## Product Change Notification / SYST-28NGOB303

ERRATA - ATmega640/1280/1281/2560/2561 Silicon Errata and Data Sheet Clarification

# ATmega640/1280/1281/2560/2561 Silicon Errata and Data Sheet Clarification

#### 100-Ball Ceramic Ball Grid Array Package (A3B) - 9x9 mm Body [CBGA] Atmel Legacy Global Package Code CPR

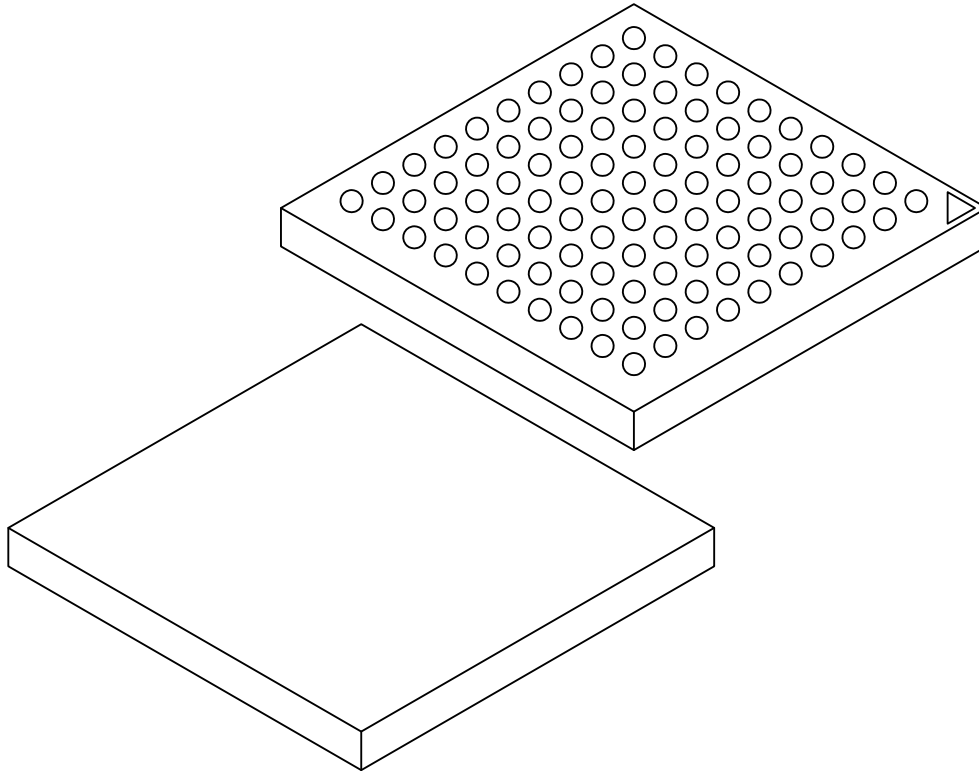
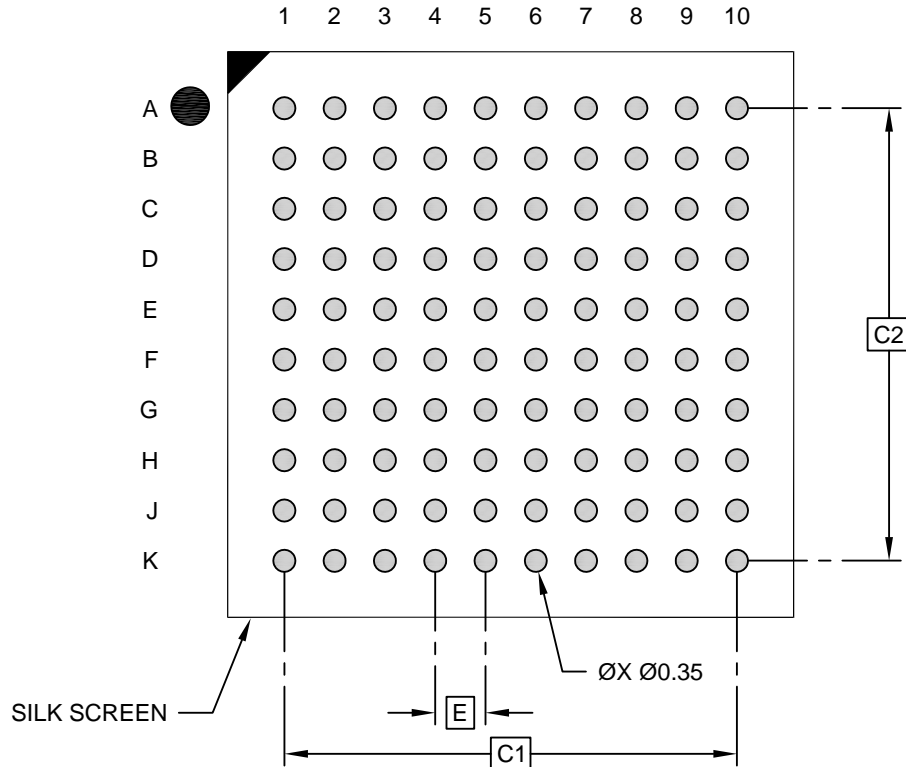
### 3.2 Packaging Information

#### 3.2.1 100-Ball CBGA

**Figure 3-1. Clock Distribution**

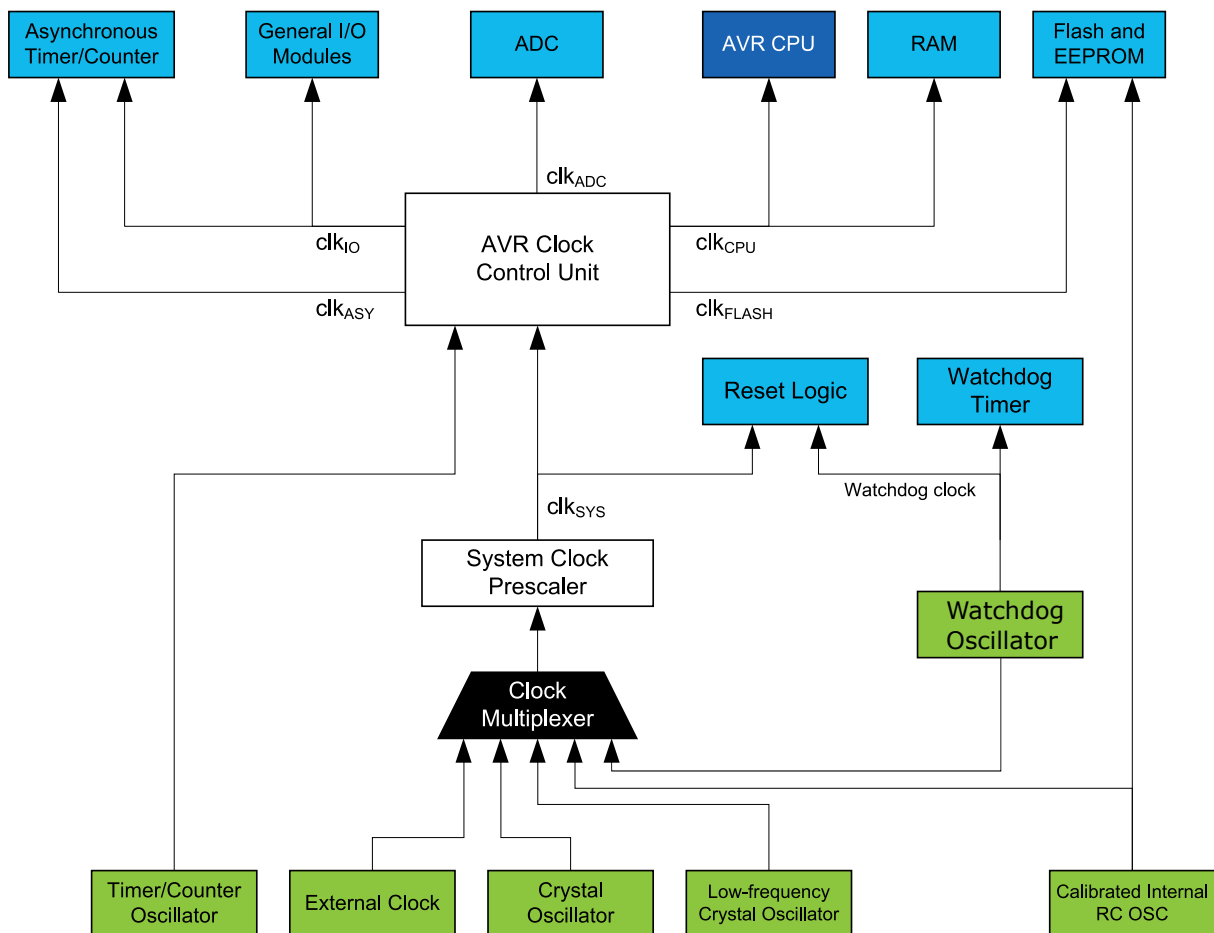
A clarification for the “*Clock Systems and Their Distribution*” section has been made.

Figure “*Clock Distribution*” presents the different clock systems in the ATmega640/1280/1281/2560/2561 and their distribution. All of the clocks need not be active at a given time. The clocks to modules not being used can be halted using different sleep modes, as described in the “*Power management and Sleep Modes*” section, to reduce the power consumption.

Figure “*Clock Distribution*” helps select an appropriate sleep mode.

**Figure 3-2. Output Compare Modulator, Timing Diagram**

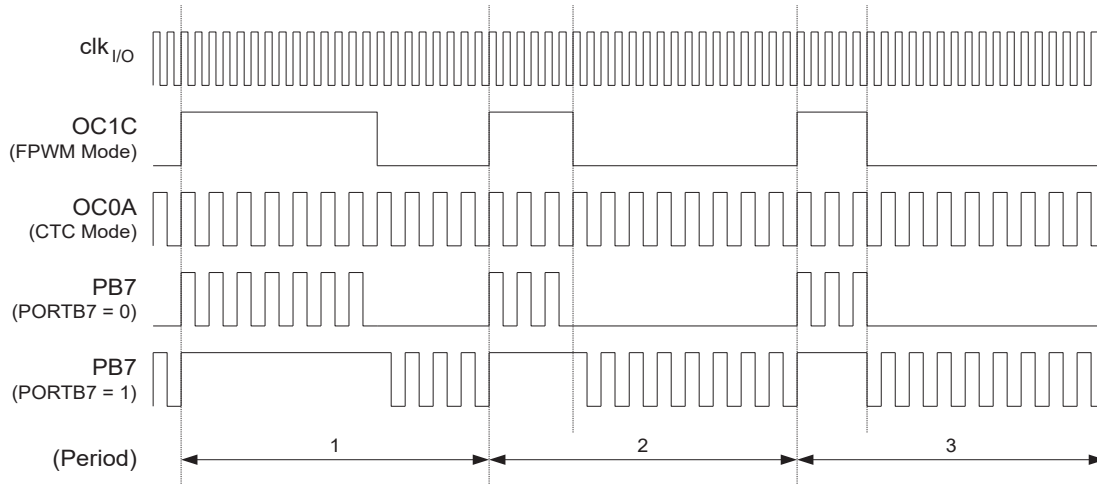
A clarification for the “*Timing example in the Output Compare Modulator*” has been made.

The following figure illustrates the modulator in action. In this example, the Timer/Counter1 is set to operate in fast PWM mode (non-inverted), and Timer/Counter0 uses CTC waveform mode with toggle Compare Output mode (COMnx1:0 = 1).

In this example, **Timer/Counter0** provides the carrier, while the modulating signal is generated by the Output Compare unit C of the Timer/Counter1.

The modulation has reduced the PWM signal (OC1C) resolution. The reduction factor is equal to the number of system clock cycles of one period of the carrier (OC0A). In this example, the resolution is reduced by a factor of two. The figure illustrates the reason for the reduction at the second and third periods of the PB7 output when PORTB7 equals zero. Period 2 high time is one cycle longer than period 3 high time, but the result on the PB7 output is equal in both periods.
